PRODUCT CHANGE NOTIFICATION

PCN No.: PCN-202611-016	**PCN Doc No.:** EC-20261120-PCN-02	**Date Issued:**	11/20/2026
Part Number or Series: MTJ-88TUX1-FSD-PG-VLD-M148C		**PCN Effective Date:**	11/20/2026
Customer: (If applicable)		**P/O No.: (If applicable)**	Not affected
Type of Change:	■ Design Change / Data Sheet Spec Change	**Last Time Buy Date:**	Not affected
Traceability Marking/Date code:	No change	**Last Time Ship Date:**	Not affected
Replacement Part Number:		**Sample Availability Date:**	Not affected

Change Description: LED assembly plastic shell changed from manual glue fixing lamp legs to automatic hot melt fixing lamp legs;

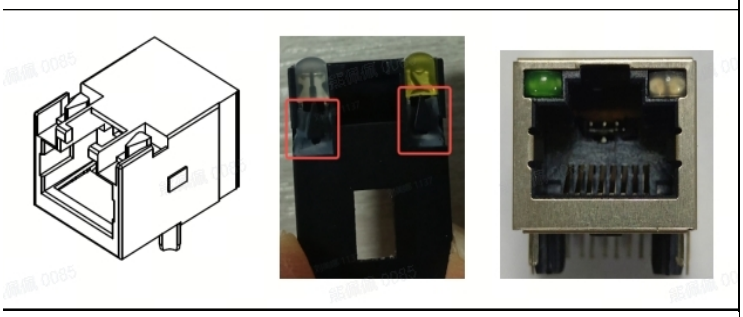
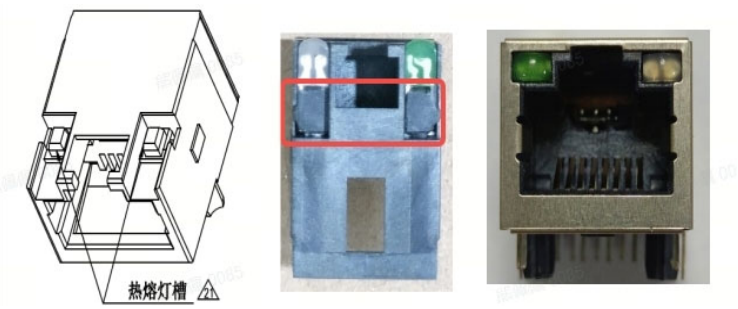
Impact of Change: The product functions are the same, but there are slight differences in appearance and size;

Before the change:
1、Appearance ~ As shown in the above picture;
2、Size:
A) 0.25~0.9mm

After the change:
1、Appearance ~ As shown in the above picture;
2、Size:
A) 0~0.70mm
